PERCOLATION TESTING

SUBDIVISION Smith Farm - Rt. 94 LOT NO. _____

Approved Perc Plan 7/27/01

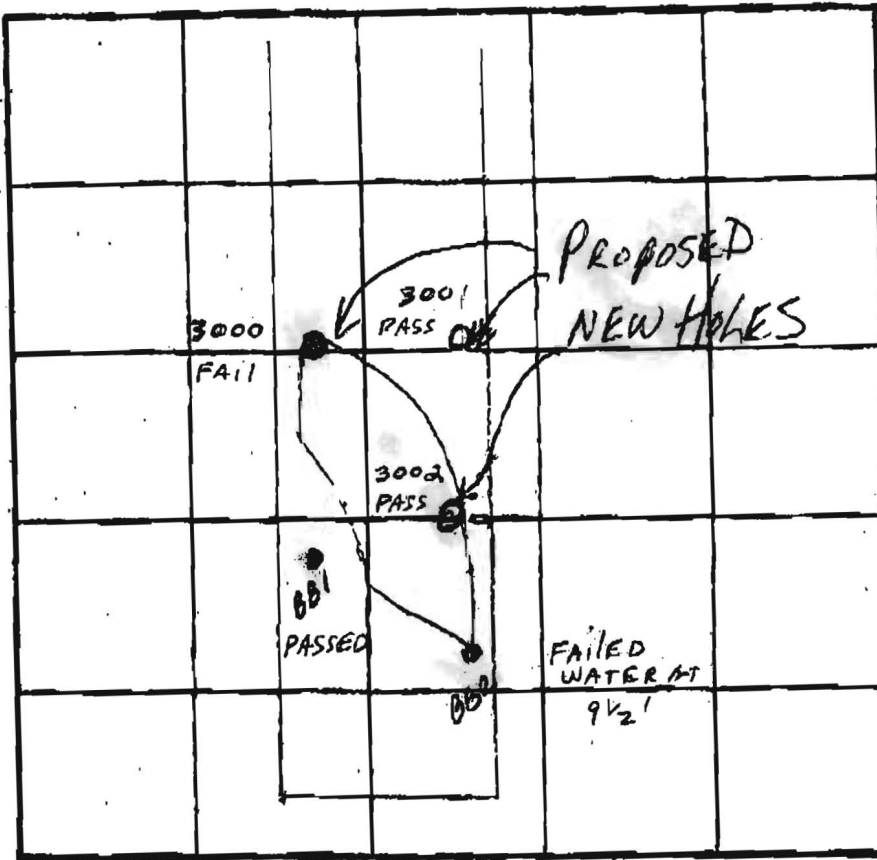
Failed due to clay layer.

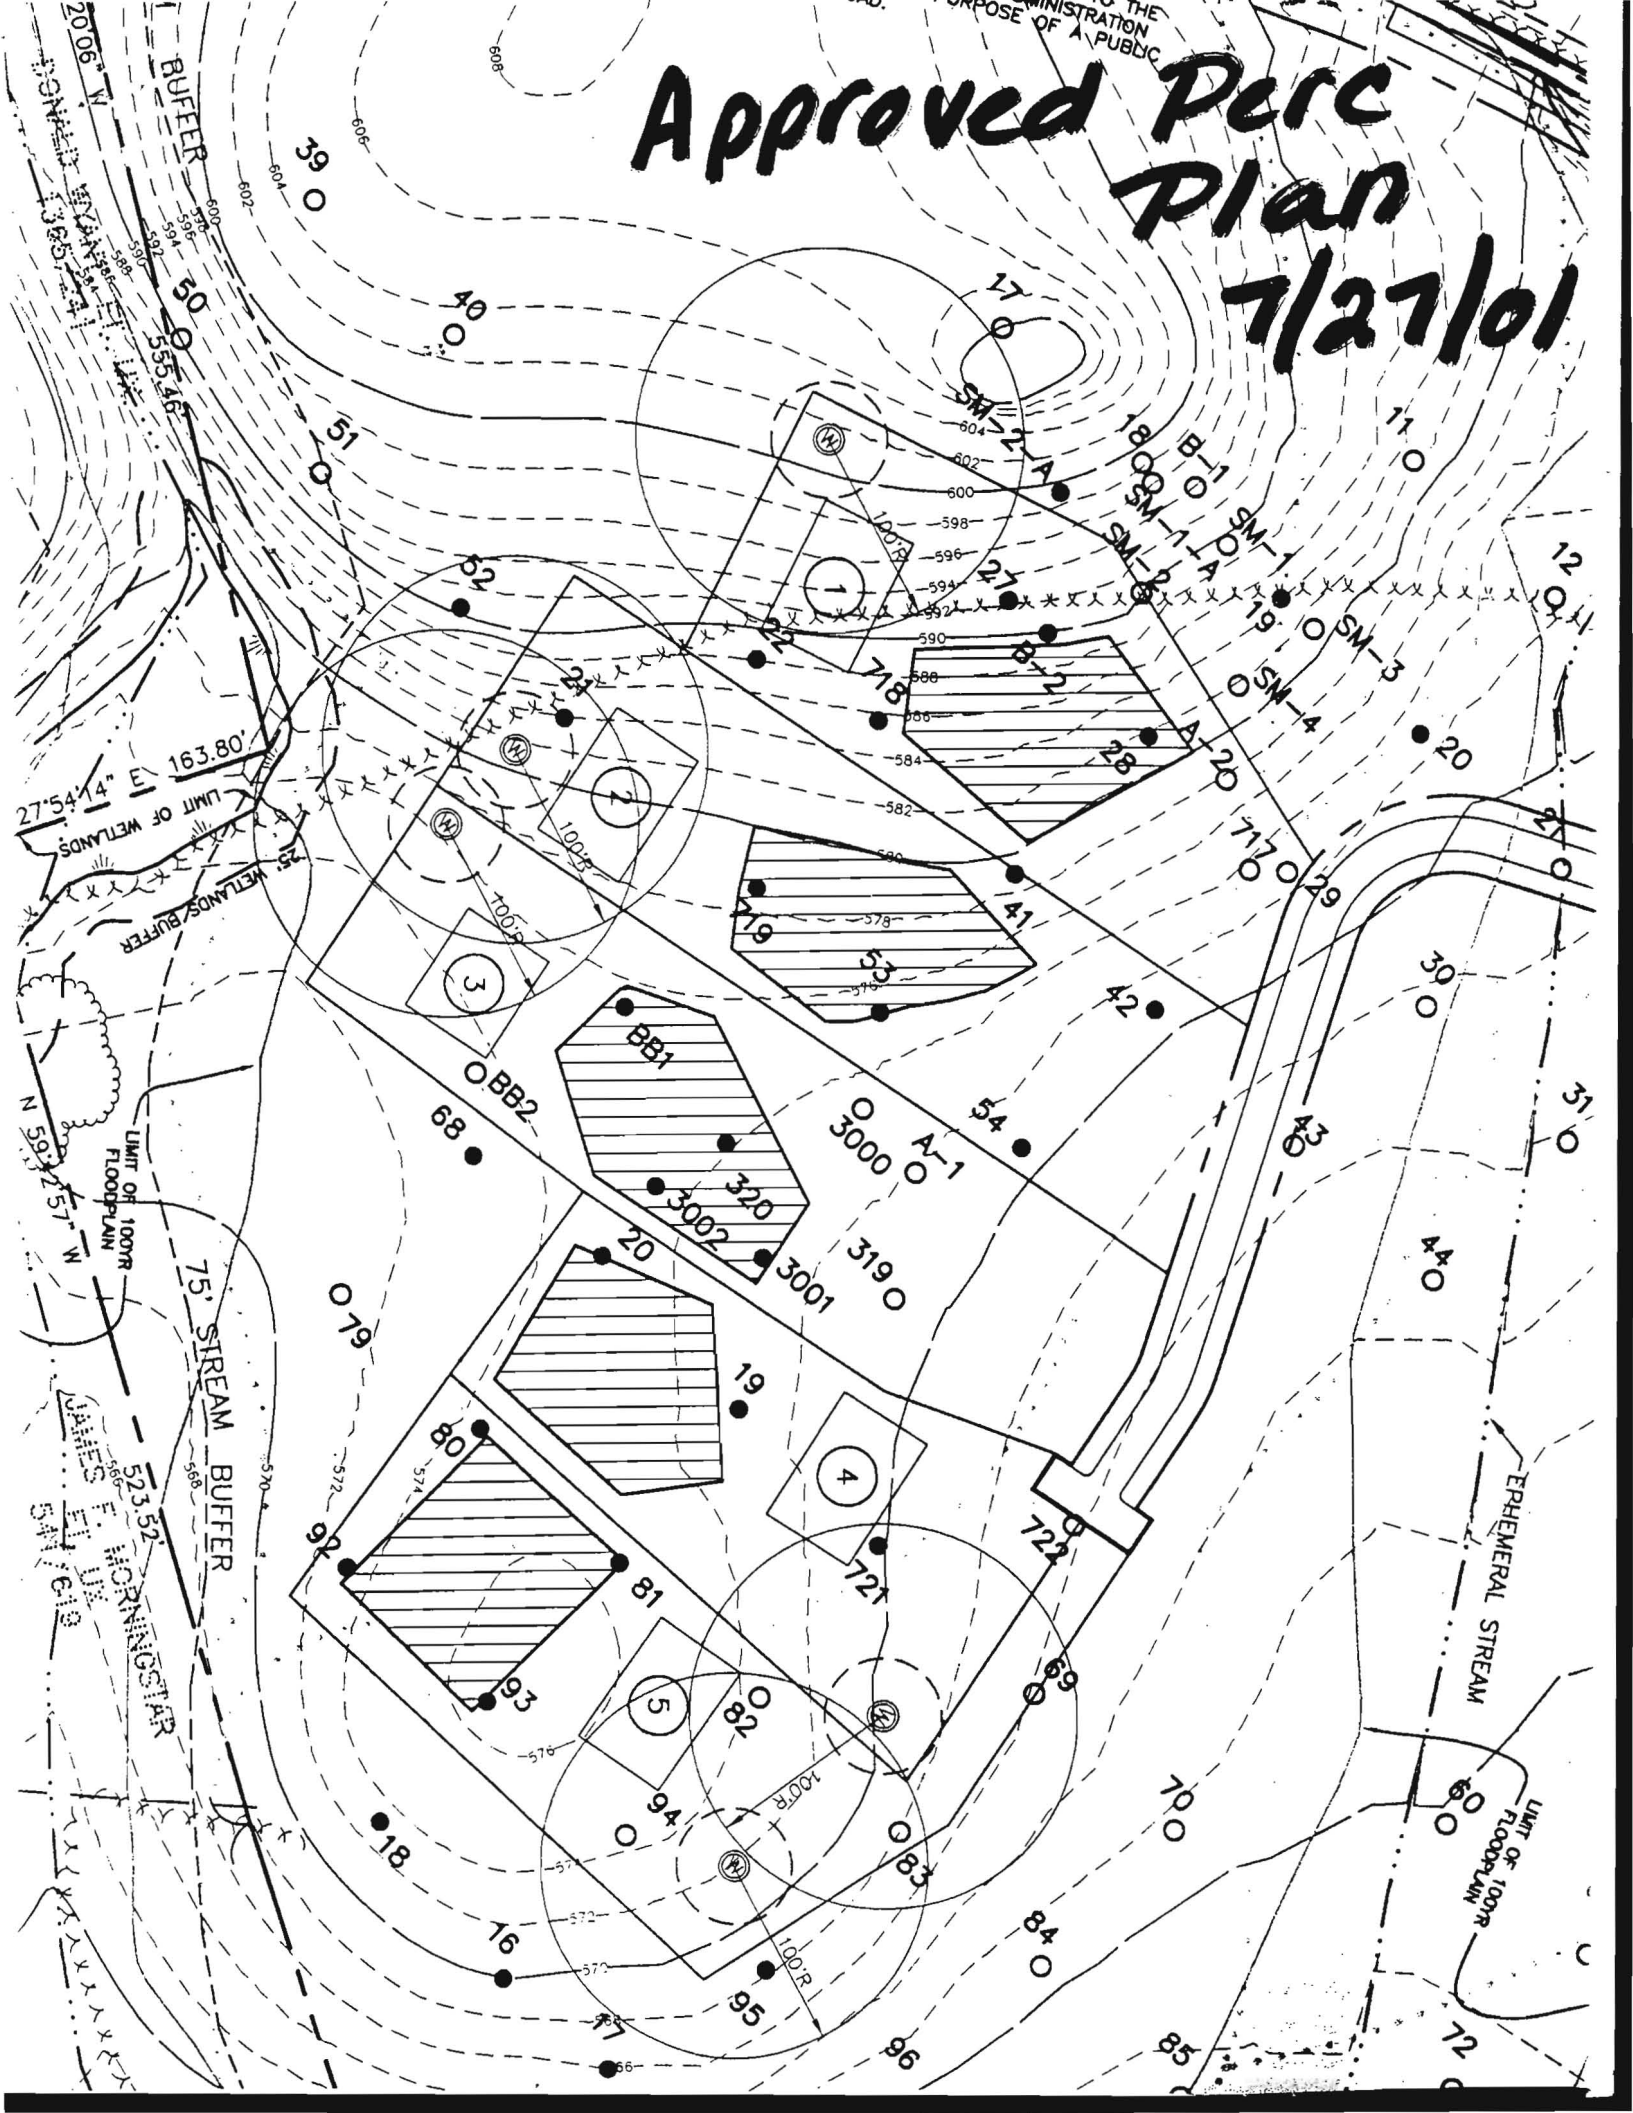
lots 7-11 OK above holes 309

2, 4, 309, 308

Holes 5 & 3 need wet season evaluation due to result on 310 @ same elevation (closure of test hole # on hole between 310 & 5)

Approved Perc Plan 7/27/01

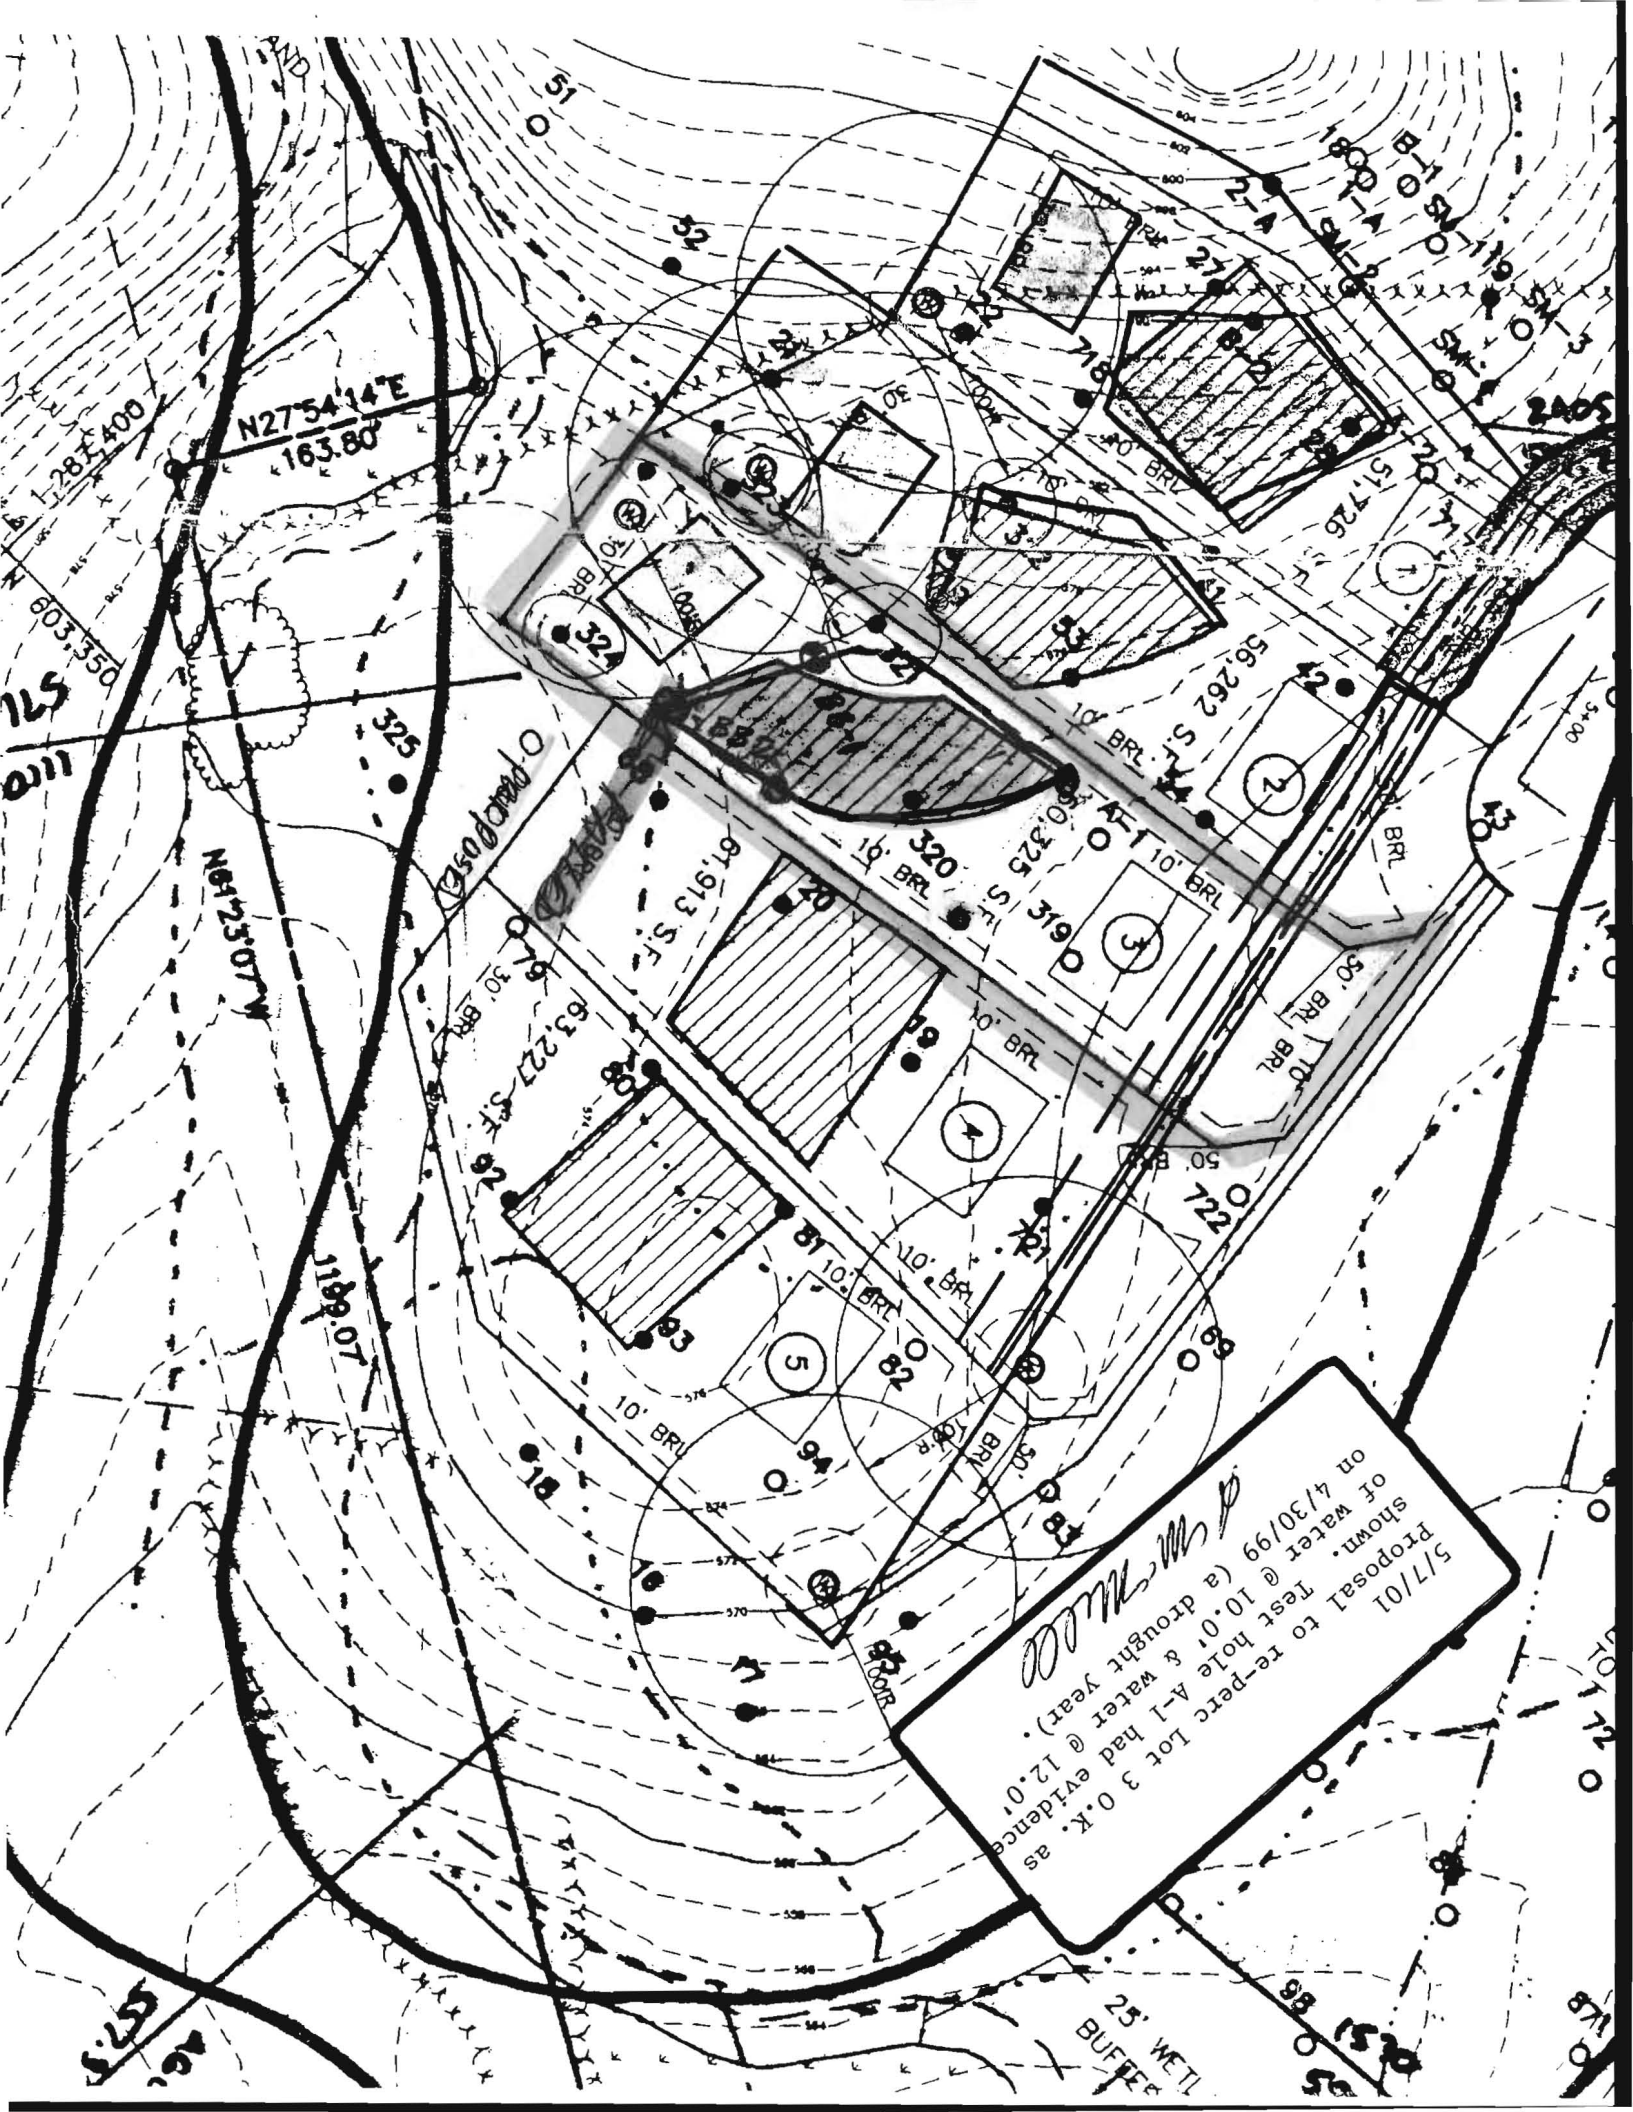
Need info on 202

Question on moving toward stream or hole 315 - must perc @ 5', if so, considered passed even though A-1 considered failed - Reasoning - proximity (linear ft) to stream.

Projected lot yield is 4 lots, if wet season is successful, you have a shot @ 5 lots.

304/305 question on H₂O (wet season testing) because evidence of H₂O in high hole, not low

W.M. Wood
 5/7/01
 Proposal to re-perc Lot 3 O.K. as
 shown. Test hole A-1 had evidence
 of water @ 10.0' & water @ 12.0'
 on 4/30/99 (a drought year).
